Forsyth County Procurement

ADDENDUM #1

Bid No. 20-171-5211

For: Providing all materials, equipment and labor for the Restroom and Bathhouse Renovations at Shady Grove Campground, Charleston Park, and Young Deer Creek Park.

Attachment for Question 11:

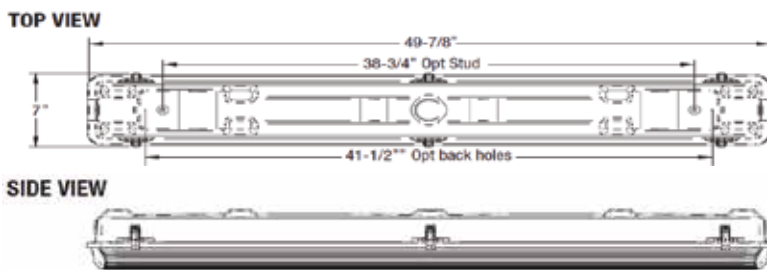
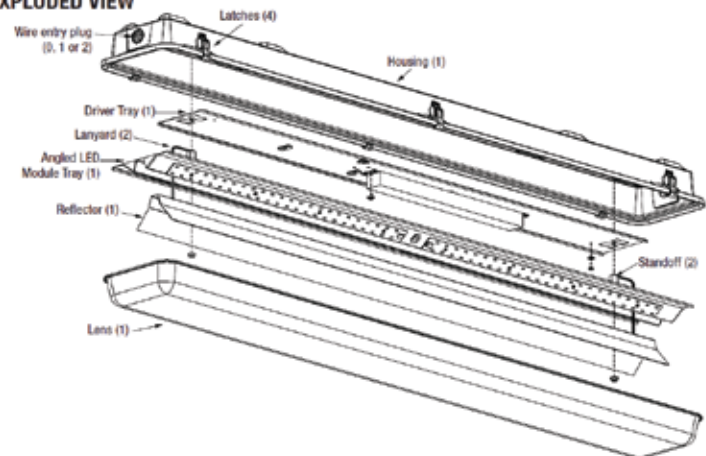
11. Q: The existing lights in Charleston Park and Young Deer Creek Park are wall mounted fixtures, but spec requires ceiling mounted LED lights. Do we remove the wall fixtures and install ceiling lights? How many of them are required in each restroom?
A: *The product that is the BOD is a surface mounted fixture, see attachment. Each restroom has 2 lights, so 4 total per park and 8 overall.*
